SURFACE TRANSPORTATION BOARD
Washington, DC 20423

June 9, 2015

Re: Docket No. FD 35852, Canaveral Port Authority — Construction and Operation Exemption — Rail Line Extension to Port Canaveral, Florida; Information Request #3

Proposed CCAFS & SR-528 Rail Alignments

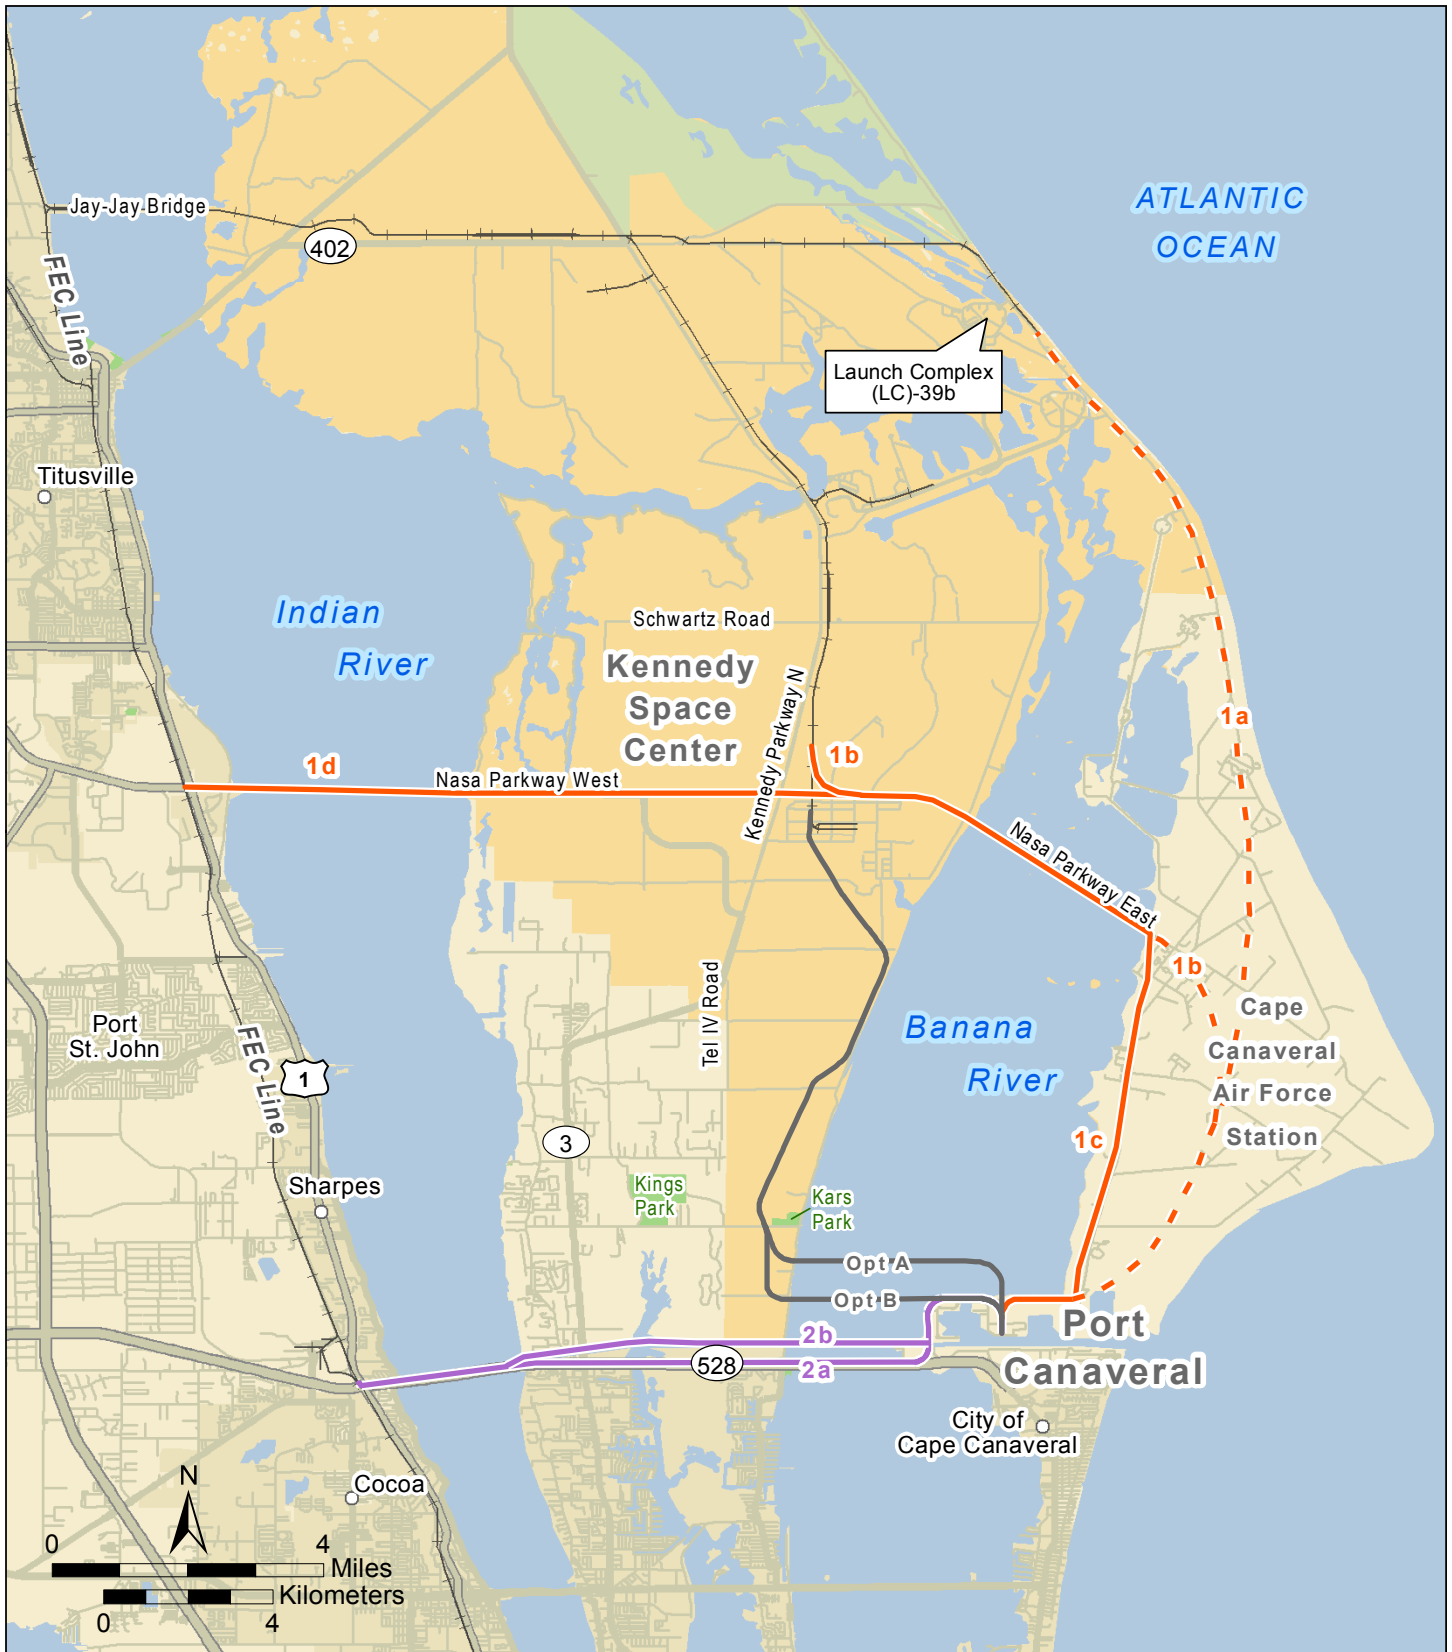
4. Question number 1 in the Second Information Request dated February 5, 2015, asked CPA to comment about the feasibility of alignments through the Canaveral Air Force Station (CCAFS) including an alignment labeled “1d”, which would enter the Kennedy Space Center (KSC) from the east on NASA Parkway East and exit the KSC on the west following NASA Parkway West (see Enclosure). In the response to the Second Information Request dated March 26, 2015, CPA noted that all alignments through CCAFS (including 1d) are not operationally feasible. However, other alignments that do not cross CCAFS—including CPA’s Option A and Option B—could utilize the segment of 1d that follows NASA Parkway West across the Indian River. Please state whether CPA considers a potential crossing of the Indian River along NASA Parkway West as feasible or infeasible. If CPA considers such a crossing to be infeasible, please provide OEA with documentation for this finding.

6. In CPA’s supplemental response to the Second Information Request received by OEA on May 22, 2015, there is no discussion of the feasibility of alignment 2b. As described in the Second Information Request dated February 5, 2015, 2b is “an alignment that would run due west from the Port, parallel to the barge canal to the Indian River, then parallel to SR 528 at the Indian River crossing until reaching the FEC.” The enclosure provided with this letter provides a depiction of alignment 2b. Please state whether CPA considers potential alignment 2b listed above as feasible or infeasible. If CPA considers alignment 2b to be infeasible, please provide OEA with documentation for this finding.

7. CPA noted in the supplemental response to the Second Information Request received by OEA on May 22, 2015 that thorough discussions had taken place with the Florida Department of Transportation (FDOT) leading up to CPA’s determination that a SR 528 rail alignment would be feasible. Please clarify the following. Is FDOT receptive to placing the proposed PCRE within the SR 528 right-of-way? Does FDOT have a preference between the north shoulder alignment and median alignment for SR 528? Please provide any documentation of these discussions with FDOT. Also, does CPA have a preference between the north shoulder alignment and the median alignment for SR 528?
